RE: PUD16-00024 & SUB16-00052 / Additional Correspondence

This item includes a conditional use permit and preliminary plat for a subdivision comprised of 60 detached single family homes on a roughly 14.5 acre site located at 2570 E. Warm Springs Avenue in an R-1C (Single Family Residential) zone.

RE: Proposed Warm Springs Village (Gate City Steel Property) SUB16-00052, PUD16-00024

Exhibit A: Map of Table Rock Fire Perimeter from Idaho Statesman October 22, 2016, with the red line indicating the perimeter of the fire. The area circled in white (which we have added) identifies the area along Warm Springs Avenue that includes the proposed development.

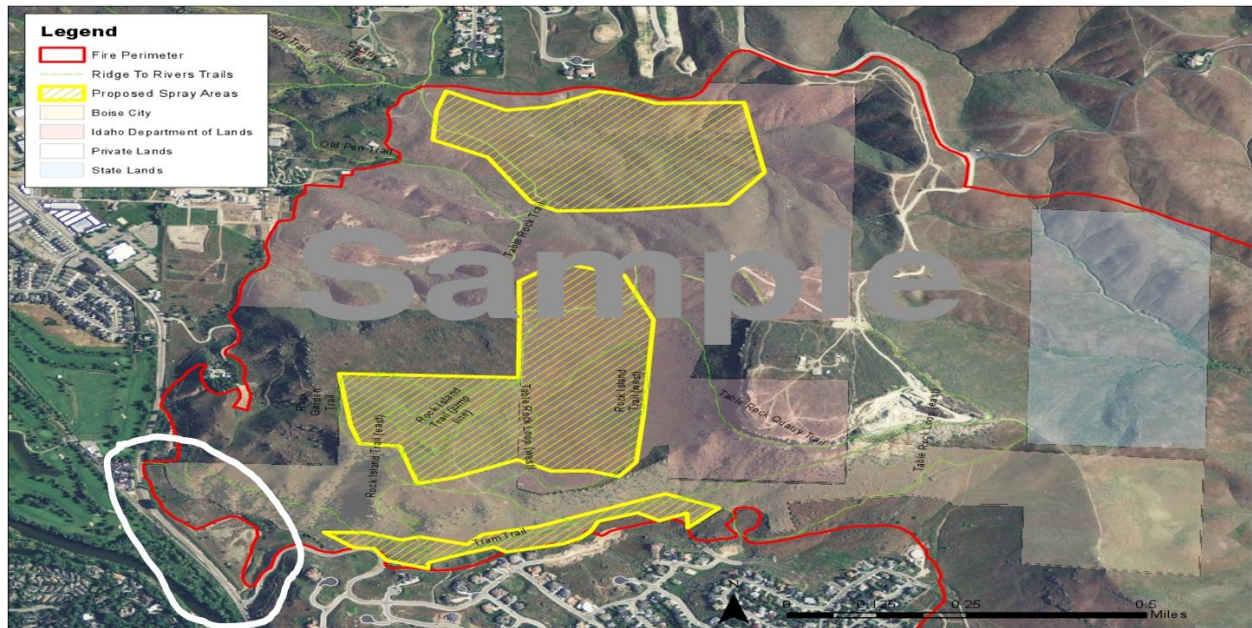
Setbacks and lot width requirements for planned developments have been established by Boise City to ensure not only visual appeal but safety concerns. Open and defensible fire space between dwellings is critical especially when the development is located adjacent to open space. This land is susceptible to wildfires and a portion of the property was burned by the Table Rock fire (see exhibits A, B and C) on June 30, 2016.

Exhibit C shows the proposed plat within the Table Rock Fire perimeter. Please note that 32 of the proposed lots are within that fire perimeter (16 lots entirely within the fire perimeter and 16 lots partially within the fire perimeter). We understand that some of the property would not have burned if the overgrowth of weeds had been eliminated. However, without adequate defensible space around the subdivision and with rooftops so close together the potential for fire jumping from home to home increases. Granting the requested reduced road/alley widths could only further hinder emergency personnel during an emergency.

We request that Planning and Zoning require a minimum 30' defensible space from all undeveloped land surrounding the property, including the Tram Trail property, and require developer to submit the wildfire safety plan prior to approving the requested plat plan.
